**To:** Adam Grady, Hanover Design  
**From:** Pat O’Mahony, Associate Planner; 910-341-0189  
**CC:** File;  
**Date:** 6/8/2021  
**Re:** Sunnyvale Drive Warehouse Facility TRC Rev. 3

Re: Administrative Variance Request – Sunnyvale Drive Warehouse Facility

■ **SUNNYVALE DRIVE WAREHOUSE FACILITY [TRC Plan Review #3]**

Pat O’Mahony- Planning – Landscape Plan

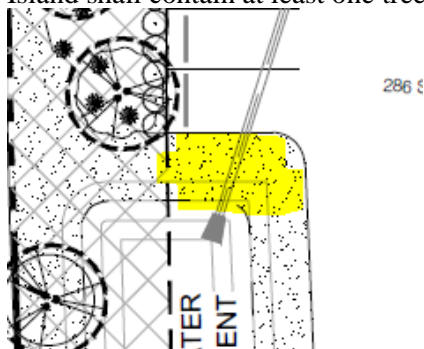
- 96 shrubs are required in the streetyard. Please update table accordingly.
- Sec. 18-481g.: Consecutive parking spaces shall incorporate landscaped islands at the ends of all parking rows.
  - Show island square footage (highlighted below).
  - Island shall contain at least one tree.
